**ITEM III-A: DESIGN REVIEW PERMIT – EL POLLO LOCO – 9501 FAIRWAY DRIVE – FILE #
PL13-0315**

REQUEST

The applicant requests approval of a Design Review Permit to construct a 2,976 square foot El Pollo Loco fast food restaurant with a drive thru and associated site improvements including parking, lighting and landscaping.

Figure 2: Site Plan

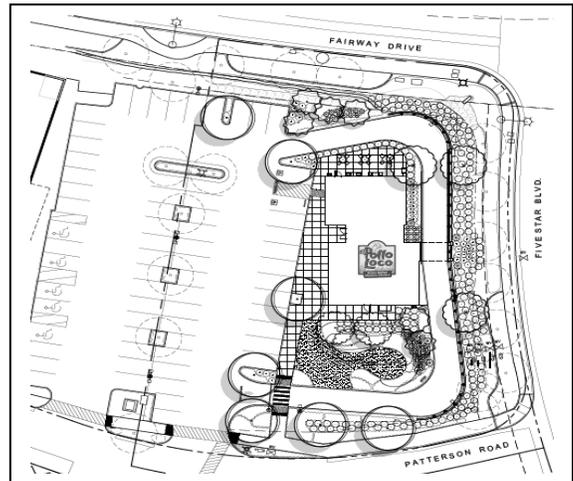
Based on the proposed site layout and size of the building, staff finds that the proposed setbacks will provide a sufficient buffer from the street allowing adequate space for landscaping and onsite improvements, while establishing an appropriate streetscape presence.

Bicycle Parking/Circulation: Per the Zoning Ordinance, a minimum of one bicycle space shall be provided for every twenty required parking spaces. Based on the parking required for the site (60), a minimum of three bicycle racks are required. The site plan does not identify the provision of bicycle parking; however, Condition #3 of the DRP has been added requiring that three bicycle parking spaces be provided in a convenient and visible location near the entrance to the restaurant.

2. The project is approved as shown in Exhibits A - E and as conditioned or modified below. (Planning)
3. A minimum of three (3) bicycle racks shall be provided onsite, within close proximity to the building's primary entrance. The quantity and type of racks shall be indicated on the site plan. (Planning)
